**Freightliner
Service Bulletin**

Heater Hose Modification

Fig. 1, Heater Installation with Close Proximity to Electric Horn

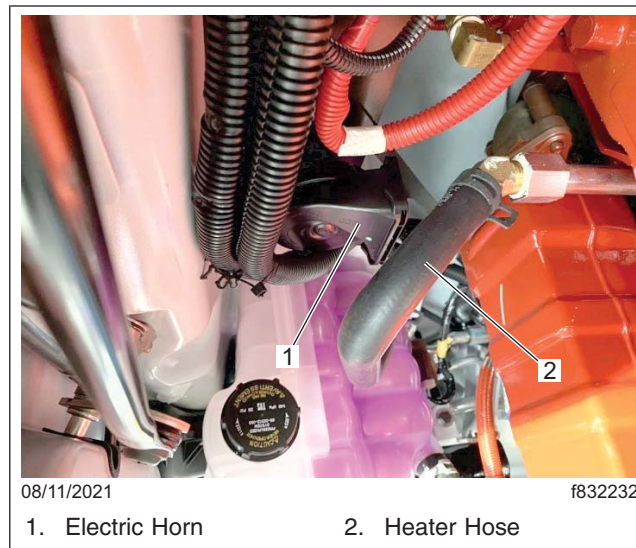
Some Business Class M2 106 vehicles built from January 2017 through June 2021 may have a heater hose installed too close to the electric horn. This applies to Business Class M2 106 vehicles with a 160 mm cab equipped with Cummins ISB engines and either single or dual horns. It also applies to heater systems with or without automatic shut-off valves. Horn failures have been reported due to high heat produced by the heater hose. In some cases, the horn comes in direct contact with the heater hose. See **Fig. 1**.

Fig. 4, Updated Heater Hose Installation

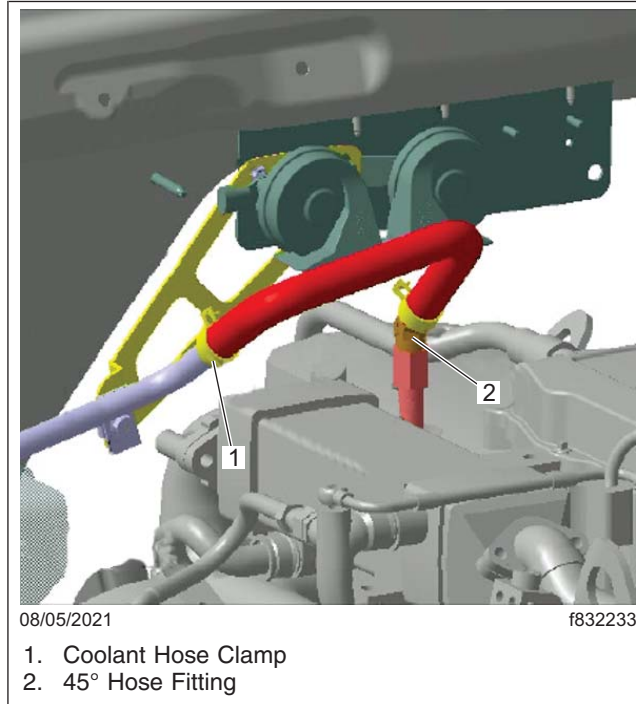
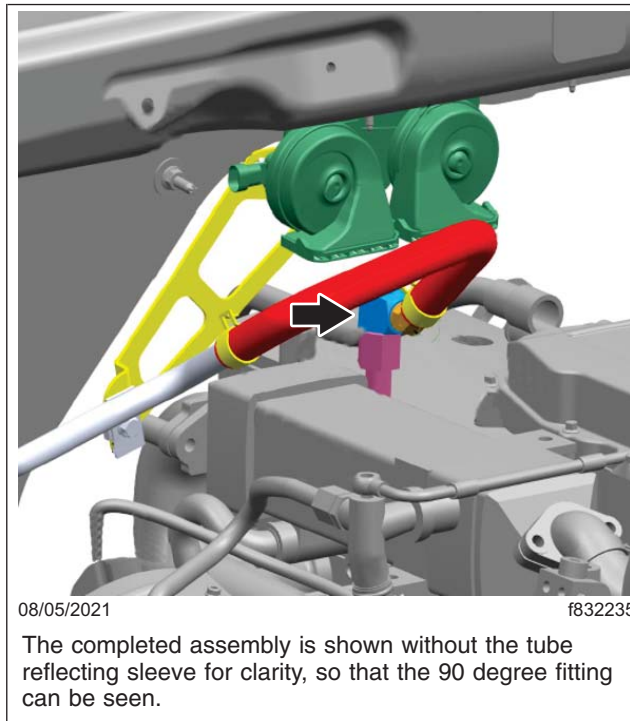
1. Park the vehicle on a level surface, shut down the engine, and apply the parking brake. Chock the tires.
2. With the ignition switch ON, check for proper operation of the horn(s). If the horn does not sound, or sound is weak, dull or abnormal, replace the horn(s) following the Horn Replacement procedure below.
3. Disconnect the batteries.
4. Open the hood to access the heater hose installation.
5. Drain the coolant.
6. Remove the coolant hose as follows.
 - 6.1 Remove the clamp opposite the 45 degree fitting, as shown in **Fig. 2**.

- 6.2 Remove the 45 degree fitting, shown in **Fig. 2**. Use a wrench to hold the end of the heater coolant supply tube as you remove the fitting.
7. Install the tube reflecting sleeve (part number BEN 476445028) on the heater hose and secure it with tie straps. See **Fig. 3**.

8. Attach the 90 degree fitting (part number 210503 000027) under the 45 degree fitting. See [Fig. 4](#).

8.1 To prevent coolant leaks, apply Loctite® 592 thread sealant to both the 90 degree fitting and the 45 degree fitting before assembly. See [Fig. 5](#).

8.3 Using a wrench to hold the end of the coolant supply tube, attach the fitting assembly to the tube. Tighten the fitting assembly 40 lbf-ft (54 N·m).

Fig. 6, Single- and Dual-Horn Installation

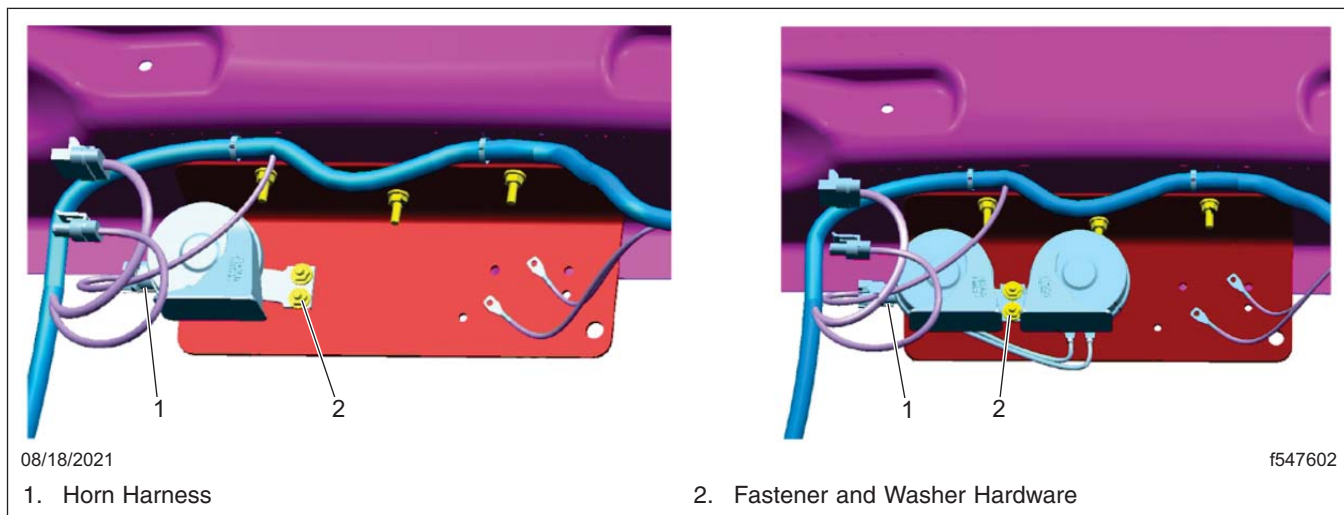
1. Unplug the horn harness.
2. Remove the two fastener and washer hardware sets. See [Fig. 6](#).

3. Replace the single or dual horn part numbers with same part number, or replacement part, per available Paragon information. Use removed hardware to install. Tighten the fasteners 48 to 60 lbf-in (542 to 678 N-cm).
